**FINAL DRAINAGE REPORT
FOR
MVEA YODER ELECTRIC SUBSTATION
EL PASO COUNTY, COLORADO**

AUGUST 2018

Prepared By:
TERRA NOVA ENGINEERING, INC.
721 S 23rd Street
Colorado Springs, CO 80904
(719) 635-6422

MVEA YODER SUBSTATION
DEVELOPED DRAINAGE MAP

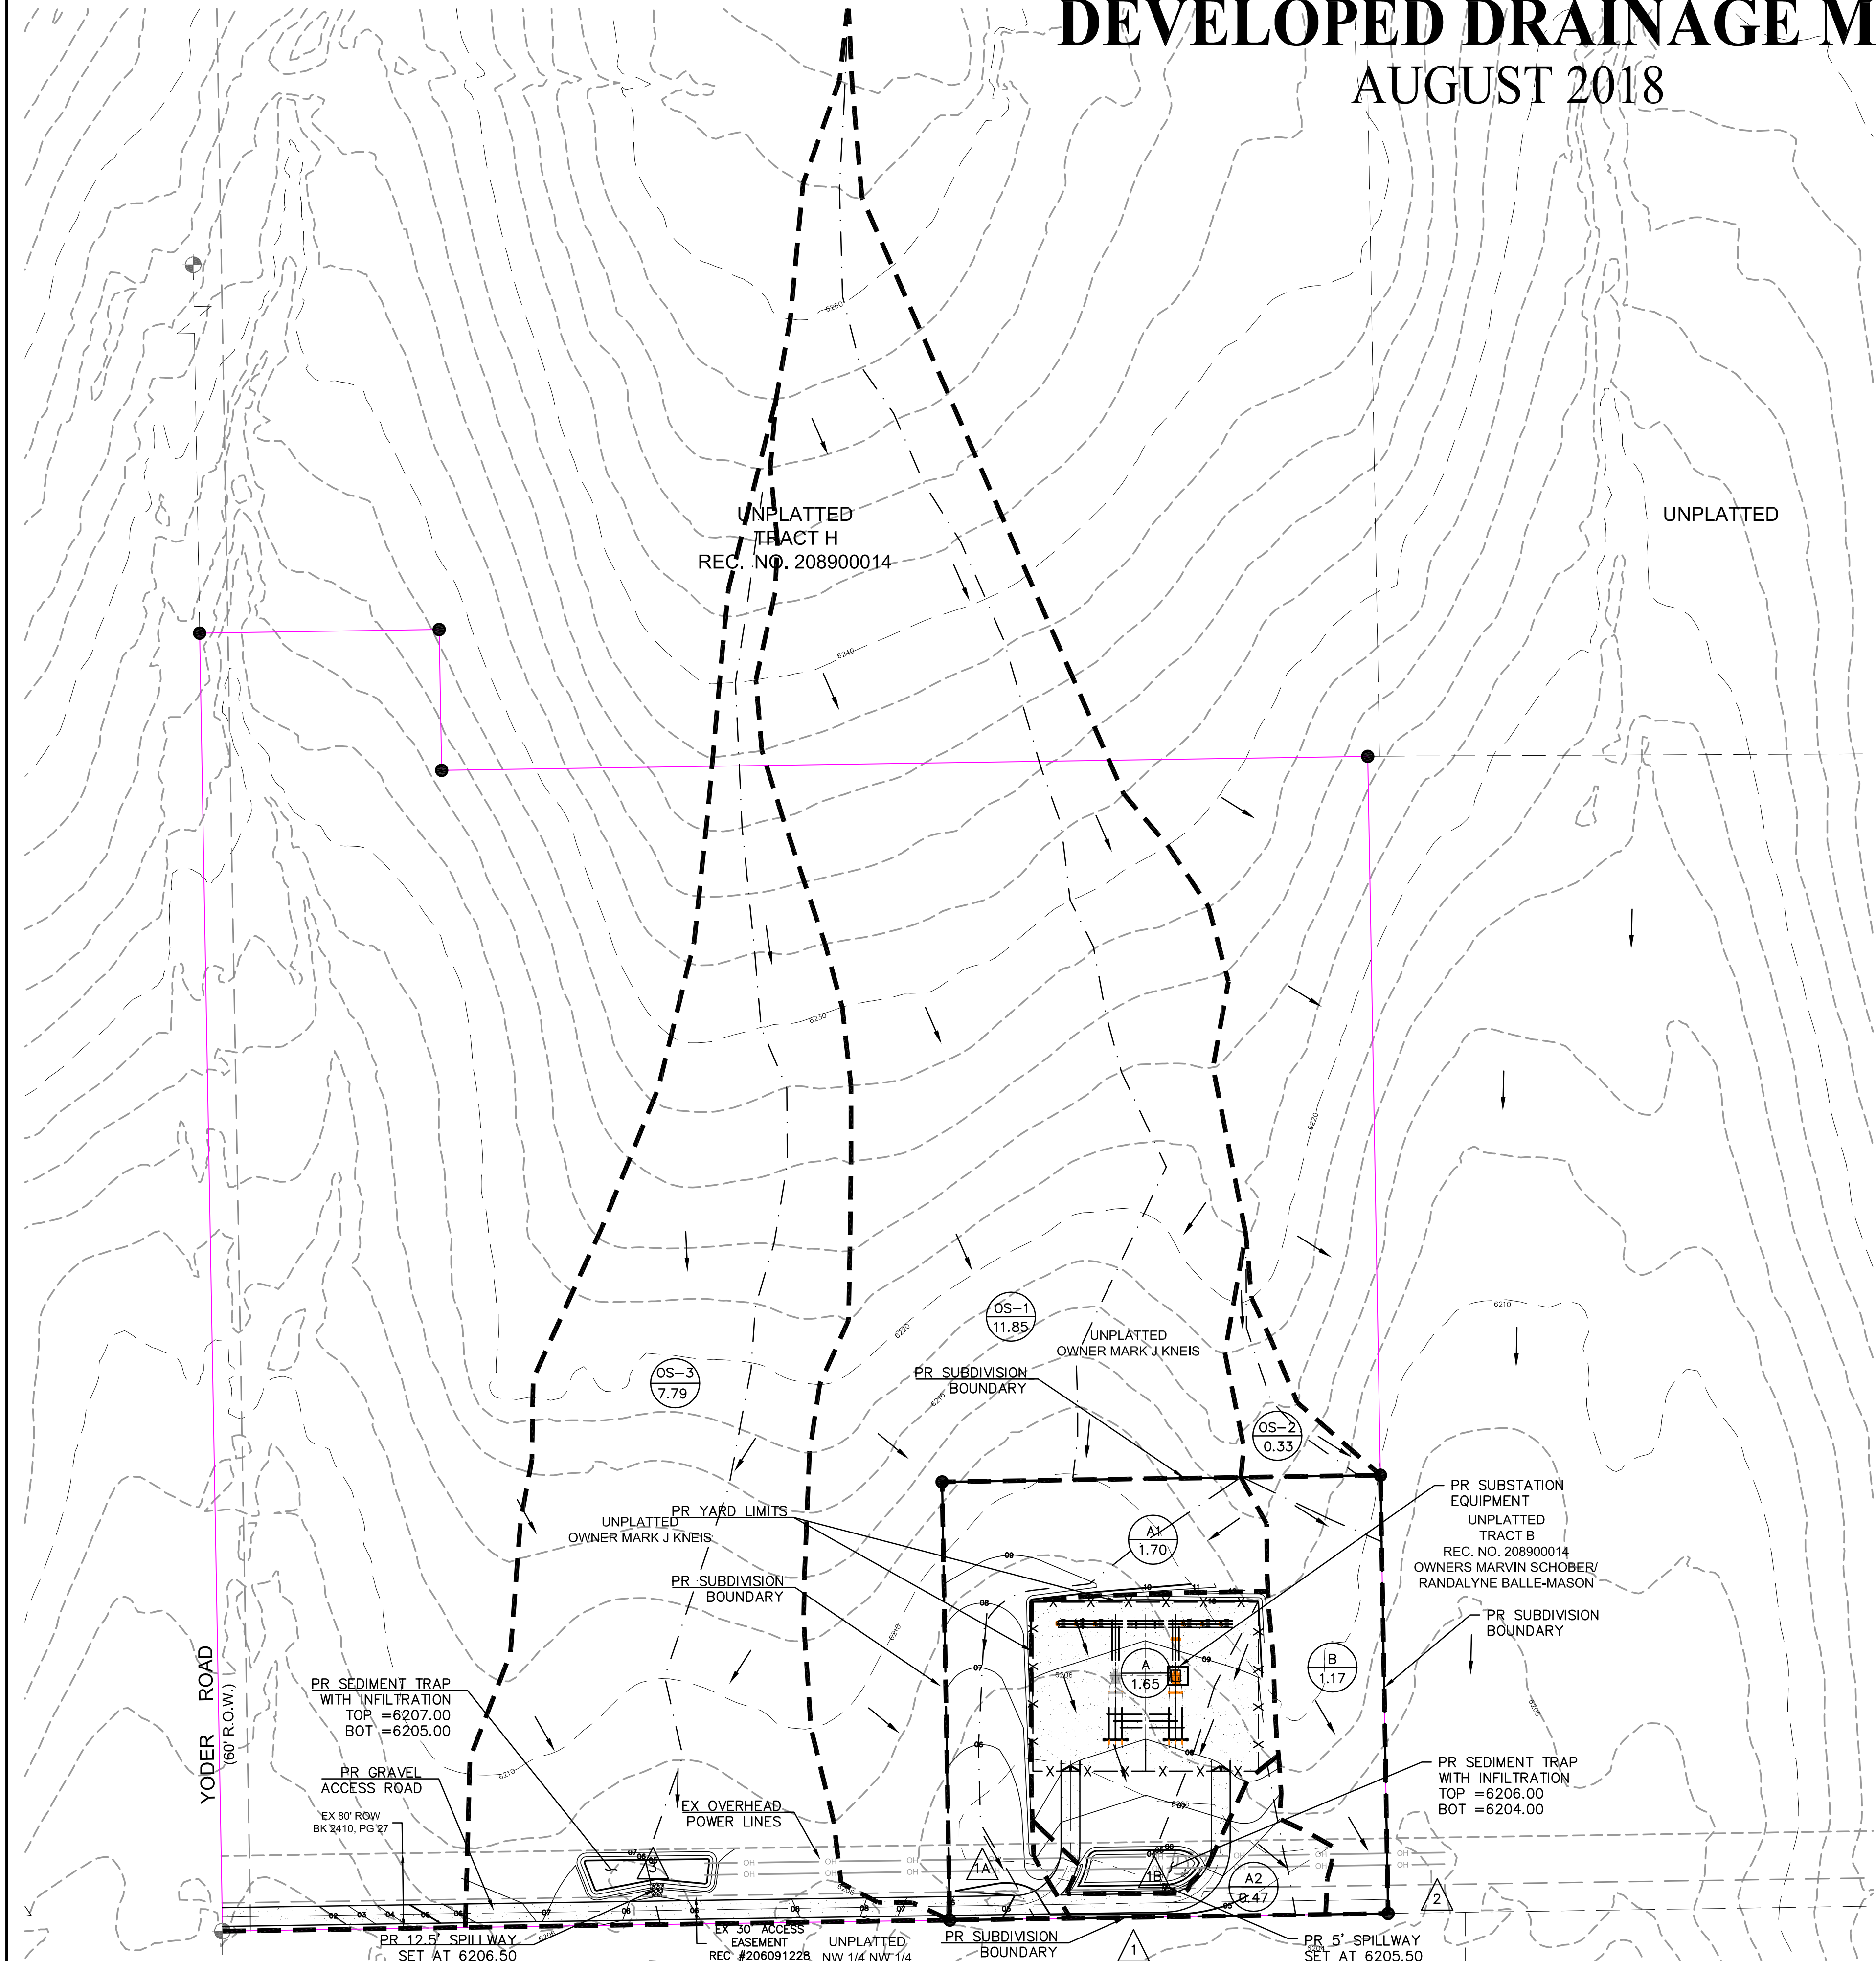
Include design points 1B and 3

Include design points 1B and 3

MVEA YODER SUBSTATION
 EXISTING DRAINAGE MAP

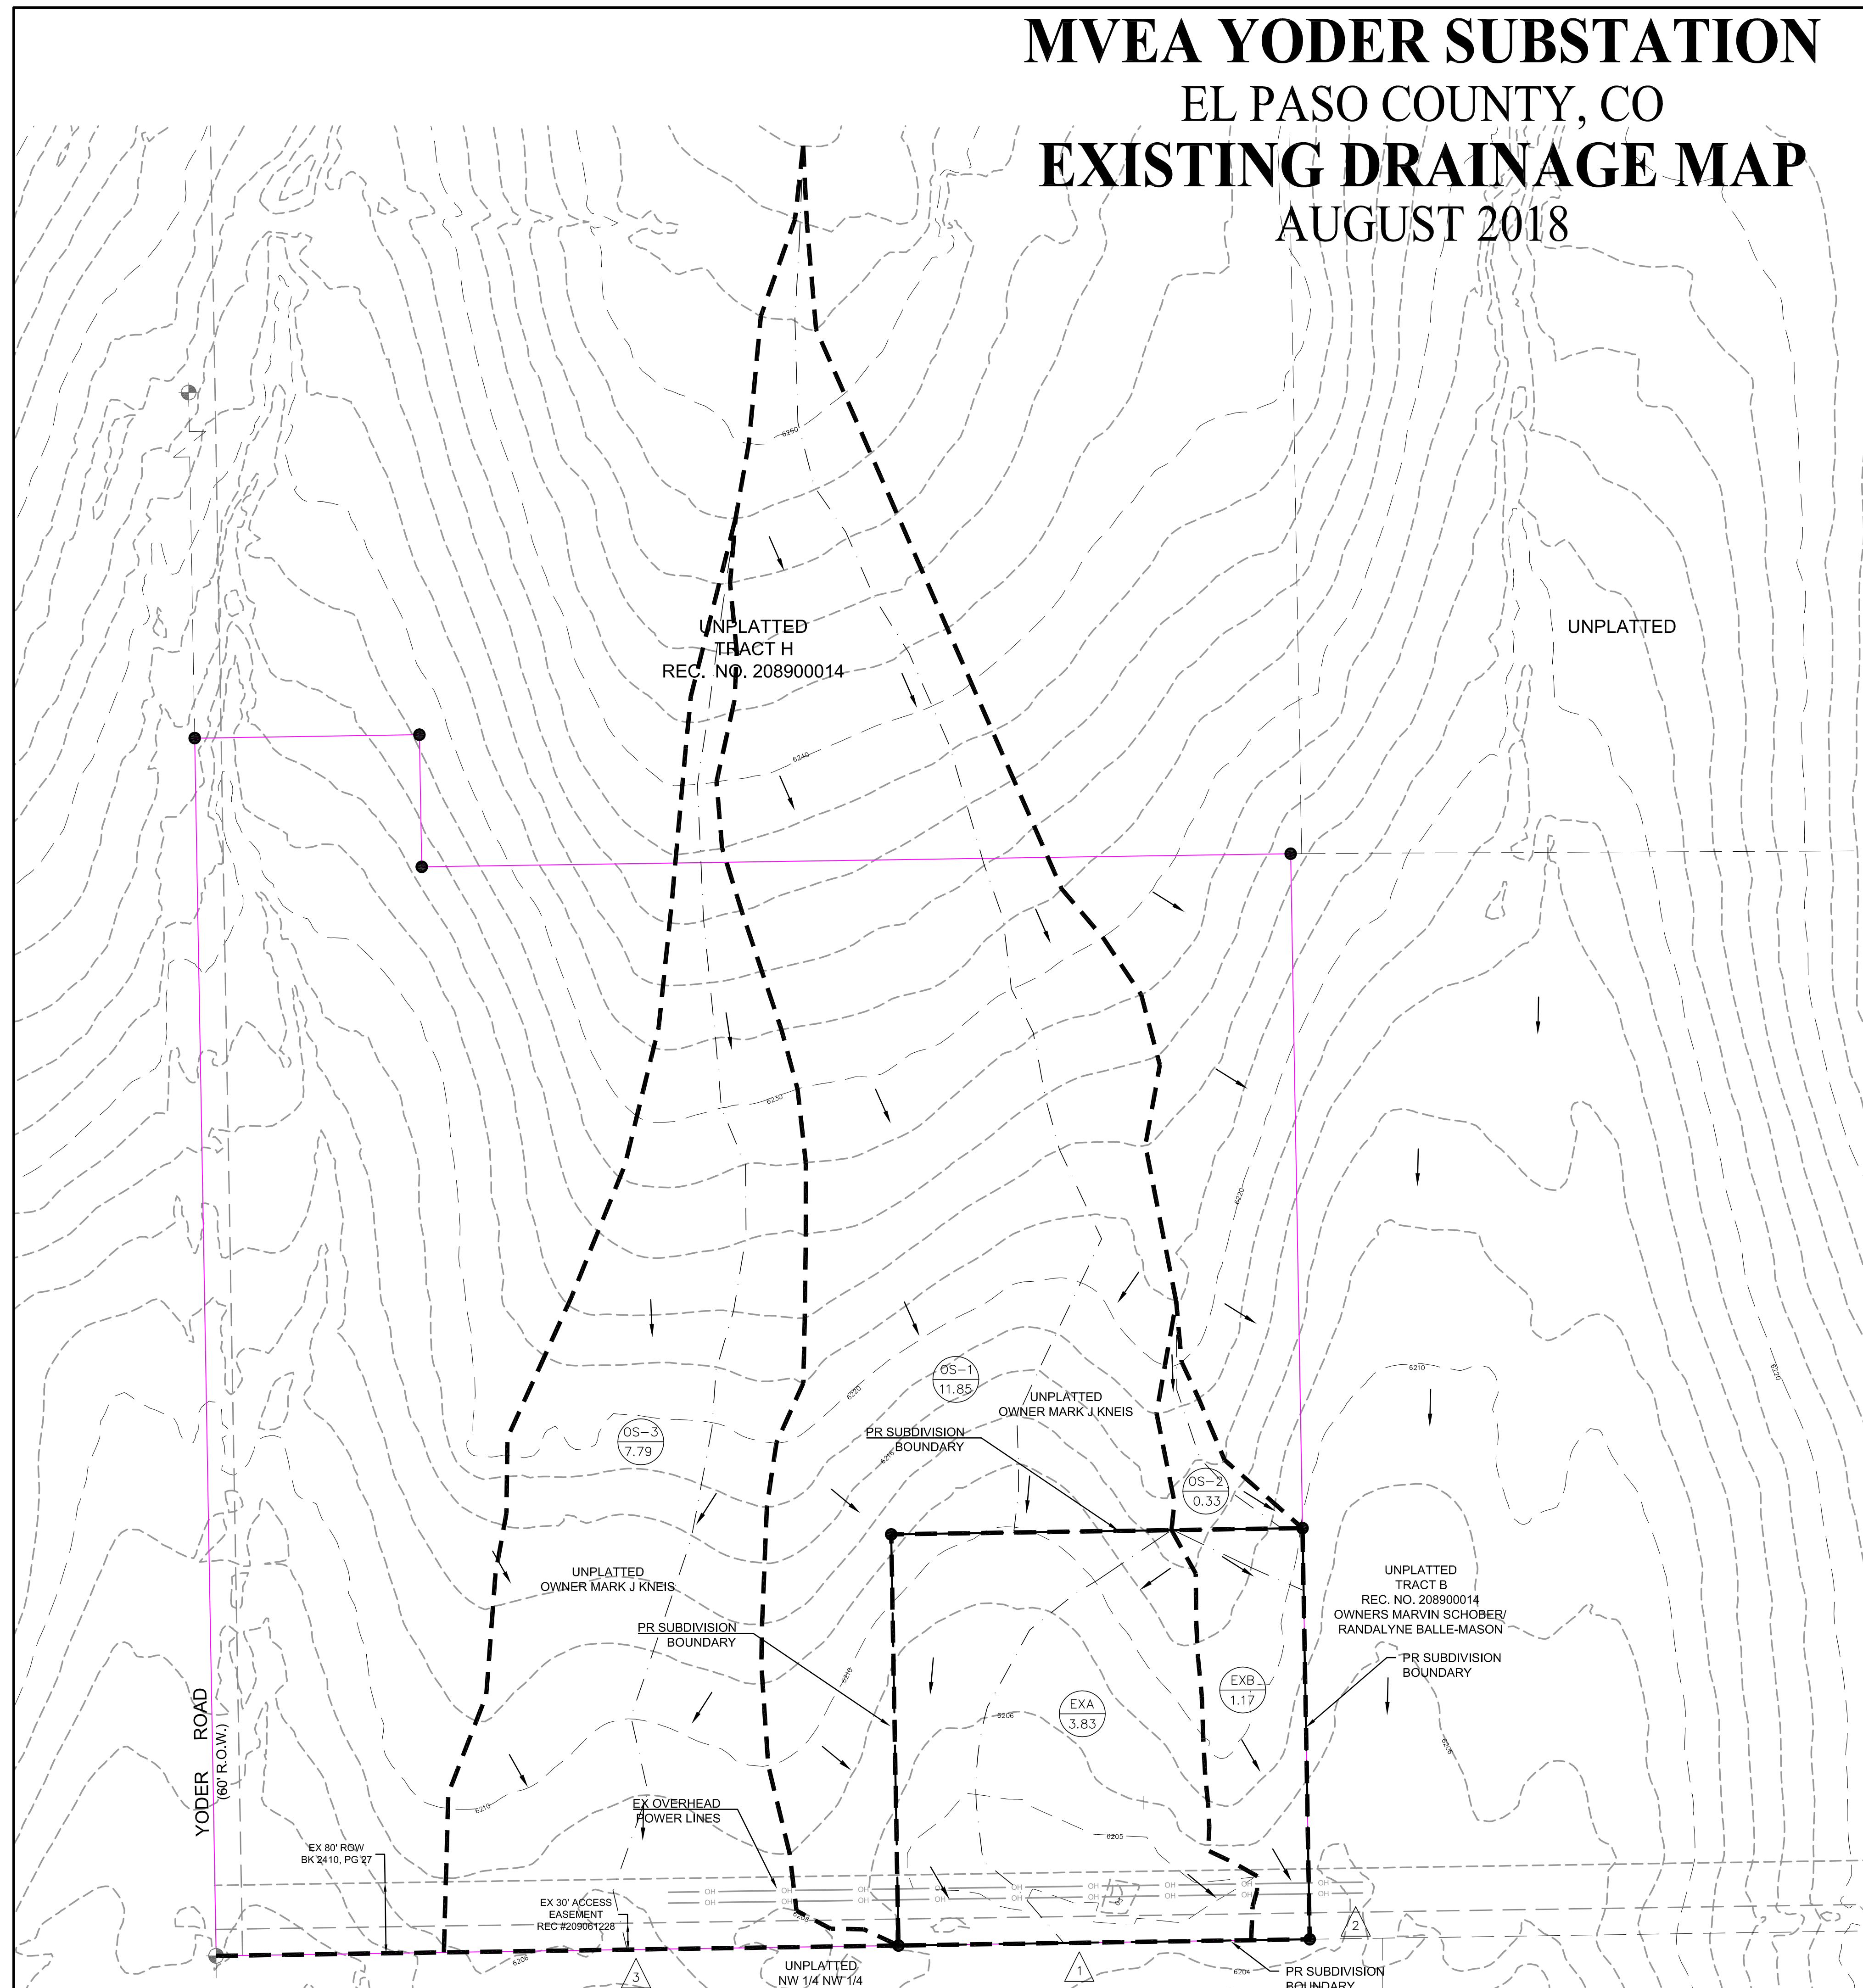
This is the existing drainage map, so existing conditions should be shown.

This is the existing drainage map, so existing conditions should be shown.
